Technical Service Information

THM 3T40 (125C) NEW LO/REVERSE PIPE SEAL

Figure 1

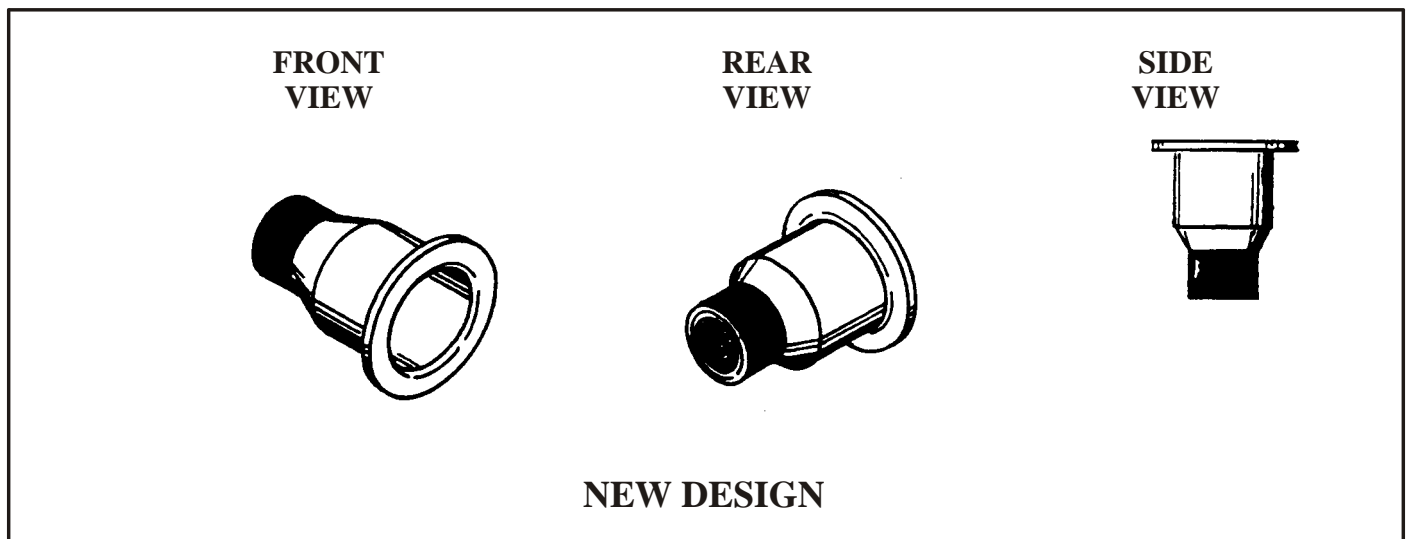
For 84 days in 1987, (Julian Date 012 to Julian Date D96), General Motors built approximately 500,000 THM 125C transaxles using a new design Low/Reverse Oil Pump Seal (See Figure 1). In April 1987, they returned to the original design seal (See Figure 2).

The 2nd design seal is available only from the GM dealer network under OEM Part No. 8664492.

The new seal must be ordered separately.

LOW REVERSE OIL PIPE SEAL (2ND DESIGN).....8664492
